**From:** Franzone, Steve [<mailto:Steve.Franzone@fpl.com>]  
**Sent:** Saturday, September 29, 2012 9:08 AM  
**To:** Comar, Manny  
**Cc:** Burski, Raymond; Maher, William; Franzone, Steve  
**Subject:** DRAFT RAI Responses FPL Turkey Point 6 & 7 for eRAI 6024 Basic Geologic and Seismic Information

**NRC RAI Letter No. PTN-RAI-LTR-041**

**SRP Section: 02.05.01 - Basic Geologic and Seismic Information**

**NRC RAI Number: 02.05.01-7 (eRAI 6024)**

**Figure 1. Locations of Storm Deposits in Southern Florida**

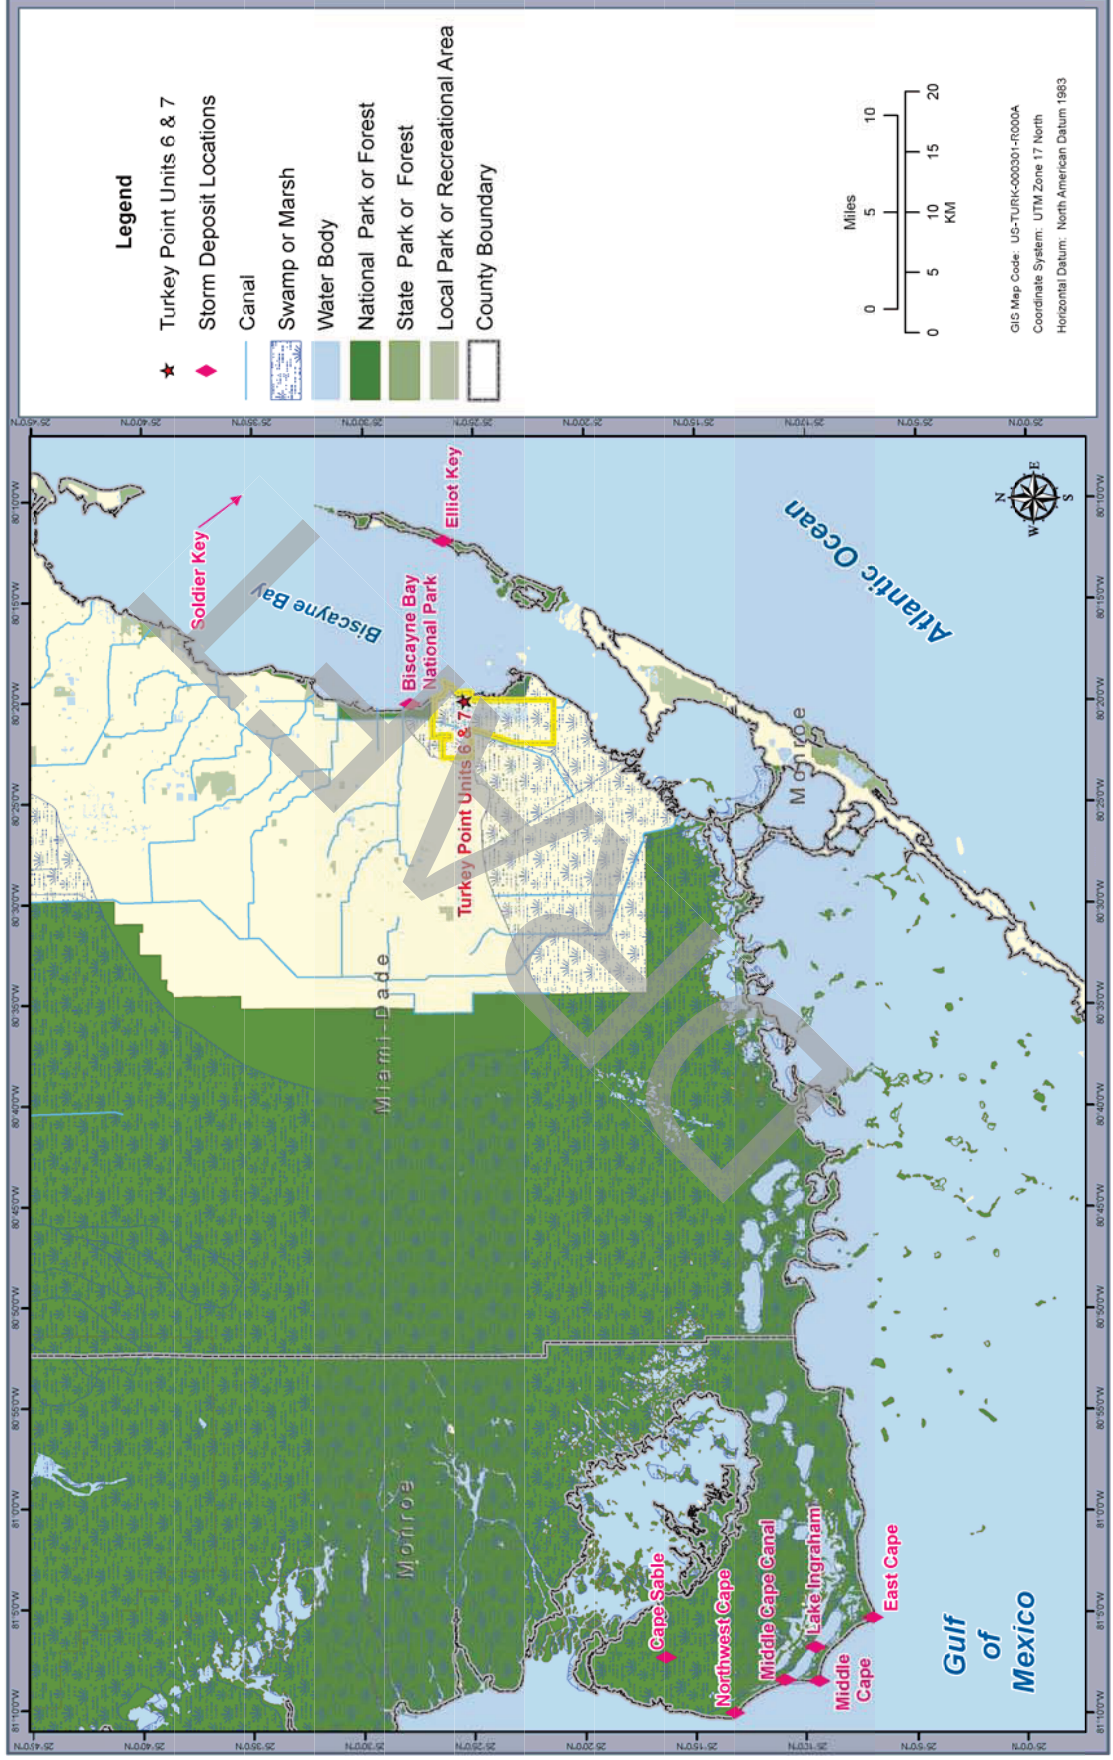
- a) Within the context of the Holocene sedimentary record at the site discuss the nature and extent of paleostorm deposits.
- b) Provide a discussion that compares and contrasts deposits of Hurricane Andrew or other historical hurricanes, and any paleostorm deposits preserved in the Holocene stratigraphy, with potential tsunami deposits at the site.
- c) Provide a figure or a map that illustrates these deposits.

Although preserved storm deposits have not been observed at the Turkey Point Units 6 & 7 site, storm deposits have been observed elsewhere in southern Florida. Storm deposits have been preserved at scattered locations on the east coast of Florida at Biscayne Bay and Soldier Key to Elliot Key. Similar deposits are documented on the west coast at Northwest Cape and Cape Sable in the Gulf Coastal Highlands of the Reticulated Coastal Swamps Physiographic Subprovince. This physiographic subprovince is shown on FSAR Figure 2.5.1-217 and the locations of preserved storm deposits are shown on Figure 1.

Since there are no paleostorm or paleotsunami deposits preserved or observed in the borings at the Turkey Point Units 6 & 7 site, there are no data from which a map can be generated. FSAR Figure 2.5.1-337, Surficial Deposits Map, shows the soils to be disturbed at the footprint of the proposed Turkey Point Units 6 & 7 and the existing cooling canals. As discussed in the response to part (b), storm deposits are only intermittently preserved in southern Florida. Storm deposits are preserved at scattered locations in southwest Florida (Reference 3) and on the shorelines of Biscayne Bay (Reference 4). The examples of storm deposits documented by Wanless and Vlaswinkel (Reference 3) and Swiadek (Reference 4) are discussed in part b) of this response and the locations are shown in Figure 1.

Figure 1. Fault Map of Western Cuba Showing Earthquakes from the Project Phase 2 Earthquake Catalog

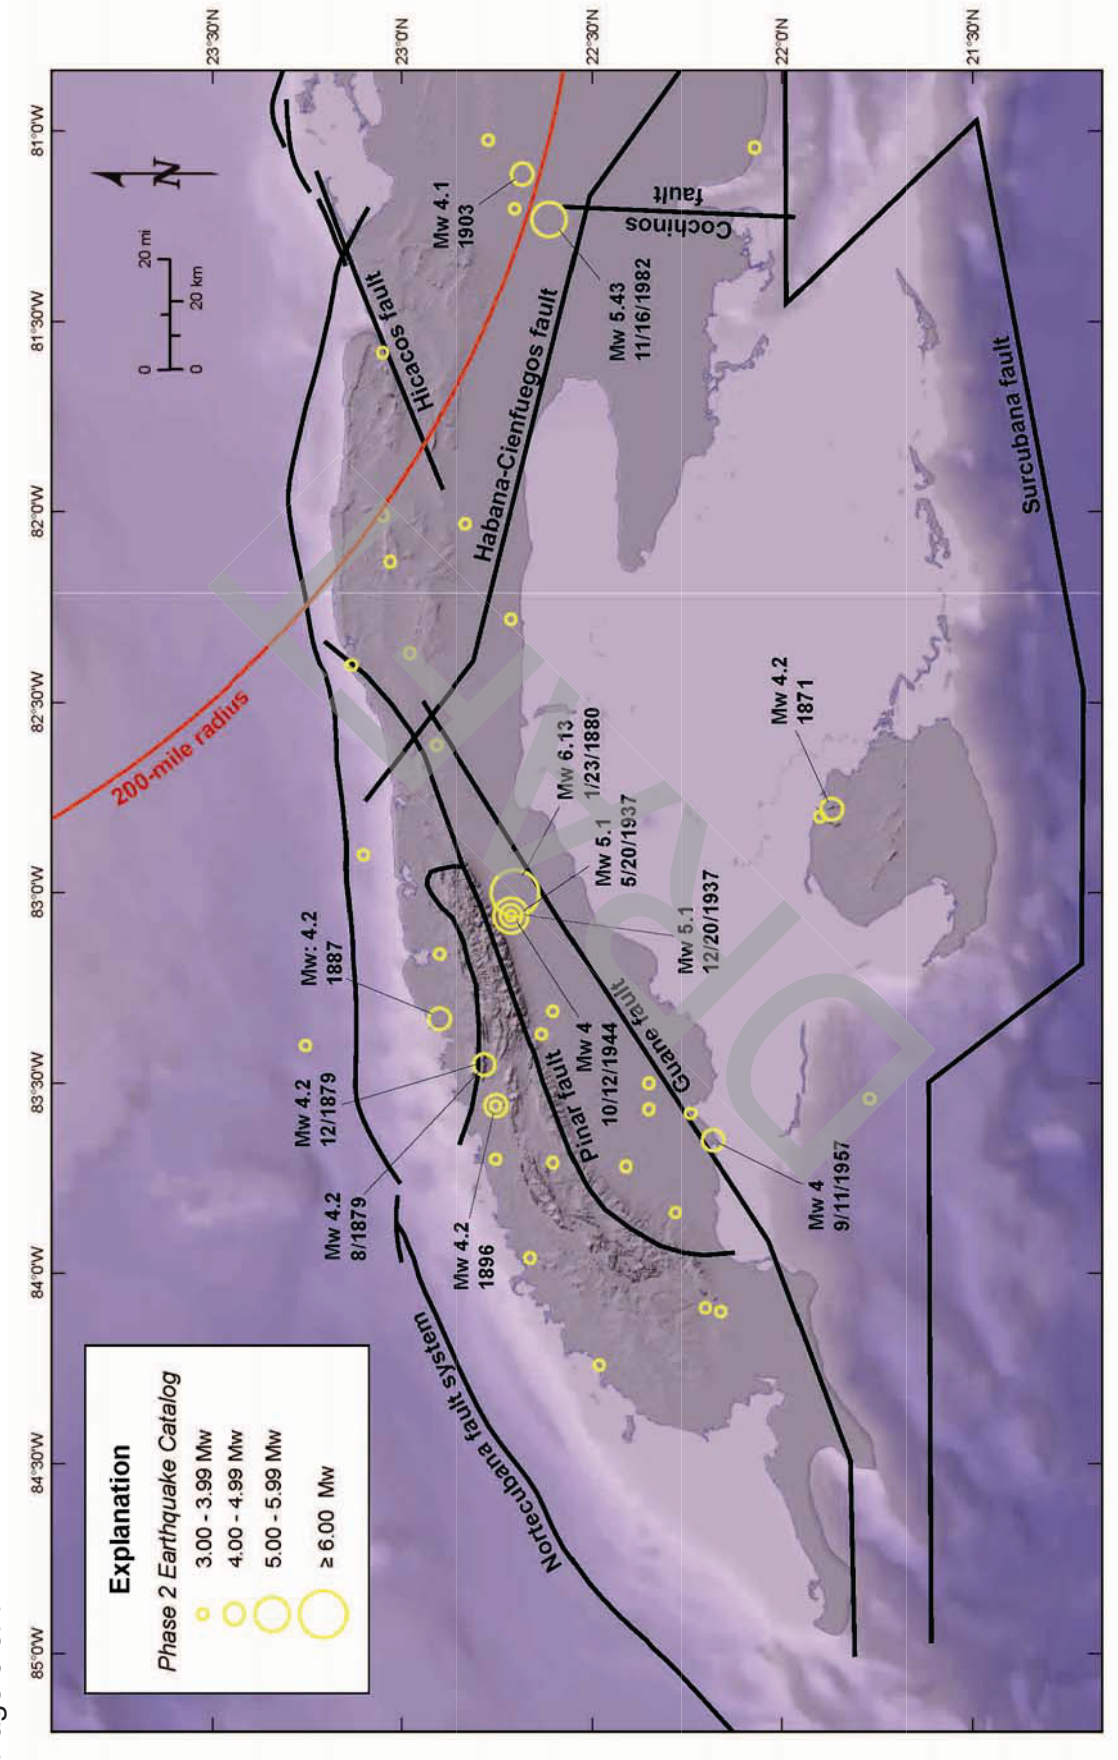
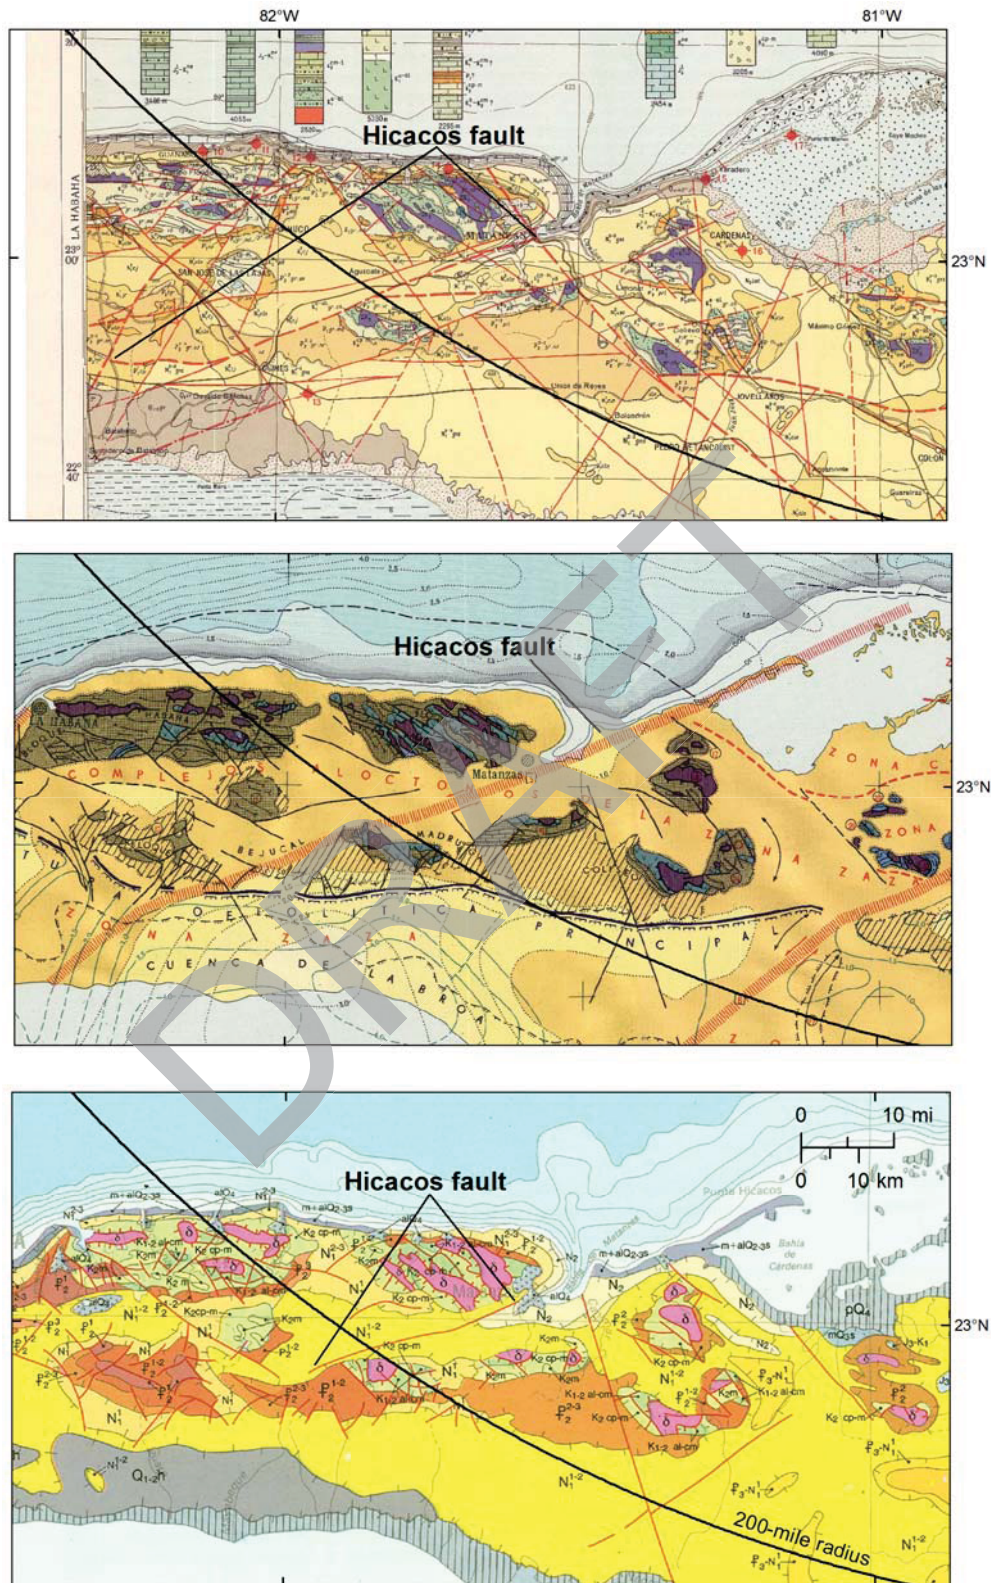
- a) Provide a discussion of the Matanzas fault zone in the FSAR, including a larger-scale map showing the fault trace.
- b) Clarify if there is a relationship between the Matanzas fault zone and elevated Pleistocene terraces along the coast near Matanzas.
- c) Discuss the relationship of the Matanzas fault zone to nearby seismicity.

The terms Matanzas fault and Hicacos fault refer to the same geologic feature. Most newer publications use the term Hicacos fault, and the FSAR follows this convention. The Hicacos fault is discussed in FSAR Subsection 2.5.1.1.1.3.2.4 and is shown in FSAR Figure 2.5.1-247. FSAR Figure 2.5.1-251 is a reproduction of Stanek et al.'s (2009) Figure 2 (FSAR Subsection 2.5.1, Reference 769), which labels this fault as Matanzas fault. The text of FSAR Subsection 2.5.1.1.1.3.2.4 and FSAR Figure 2.5.1-251 will be modified to indicate that Matanzas fault and Hicacos fault are two names for the same geologic feature. Figures 1 and 2 provide larger-scale maps of the Hicacos fault trace.

Pushcharovskiy’s (1989) (FSAR Subsection 2.5.1, Reference 847) 1:500,000 scale tectonic map of Cuba shows the northeastern extent of the Hicacos fault similar to the depiction shown in Figure 1 that terminates to the southwest at Cuba’s southern coast (middle panel of Figure 2).
